**Sewage Facilities Planning Module Review for Onlot Sewage Systems
Proposed in High Quality and Exceptional Value Watersheds**

DEP ID: 385-2208-001

Draft Technical Guidance Document, published March 2, 2013
Sewage Advisory Committee Comments

TECHNOLOGY E: Drip/Trickle Irrigation

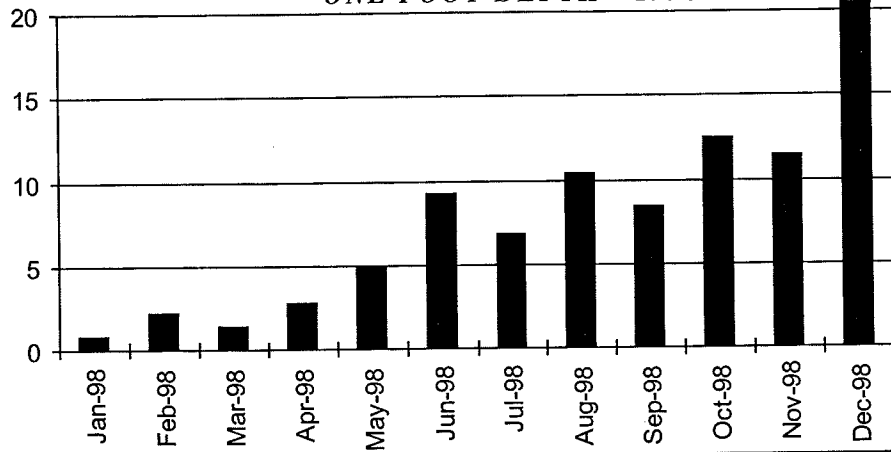
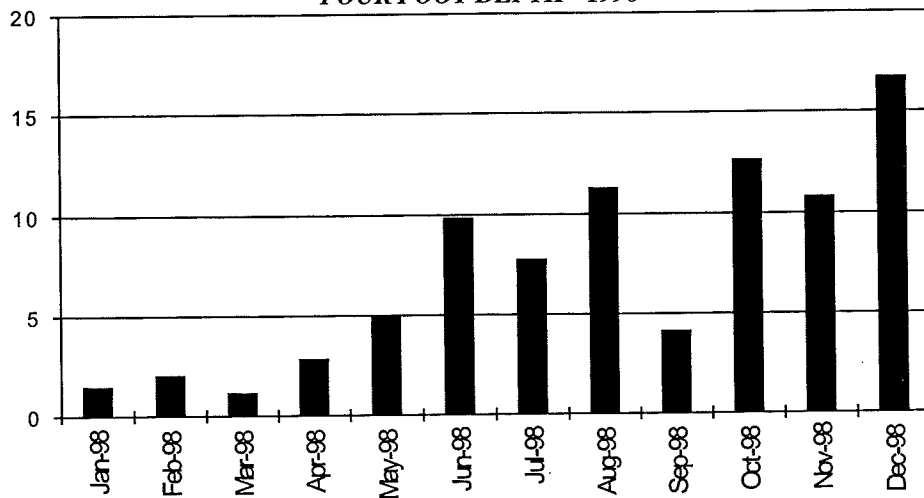
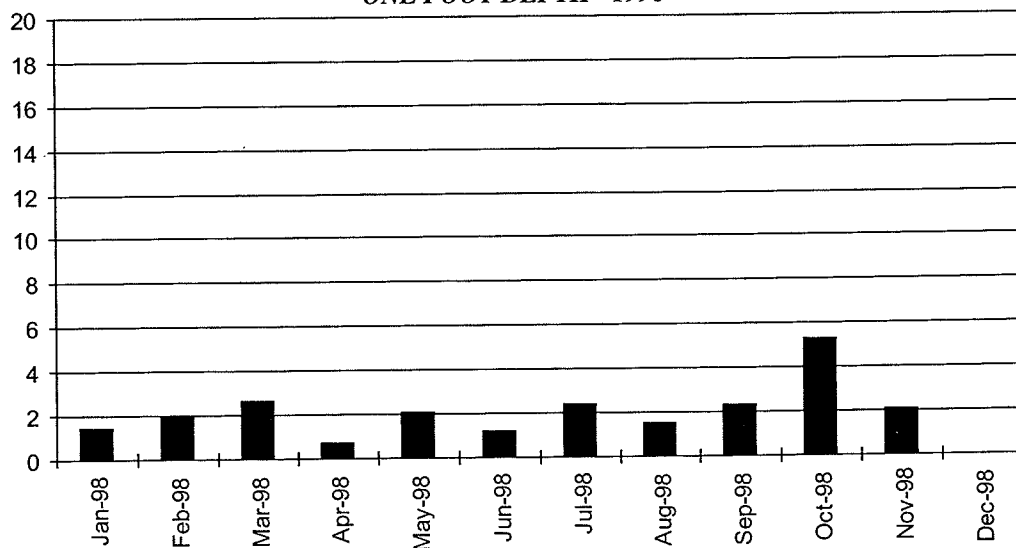
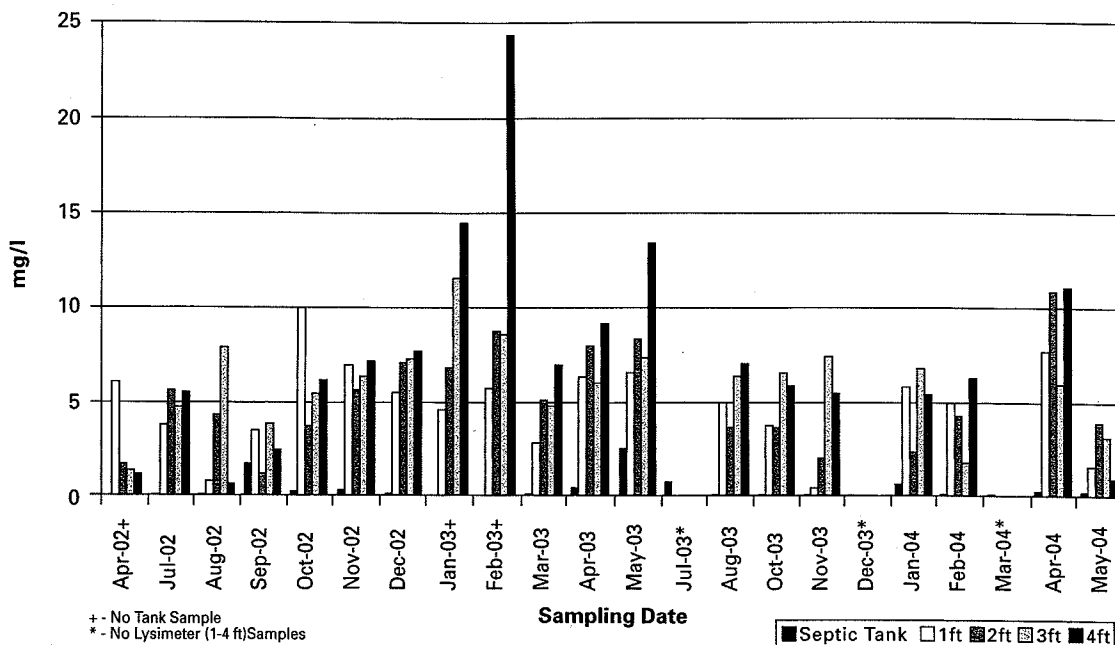
16. The data from the DelVal Phase I and II studies (see attachments) indicate that nitrate concentrations in the absorption areas beneath operating drip systems typically are less than 10 mg/L. These findings are consistent with other studies demonstrating that shallow placement and even distribution allow for nitrate reduction. Therefore, the Department should include drip systems as a BMP and assign a protection factor of 4.
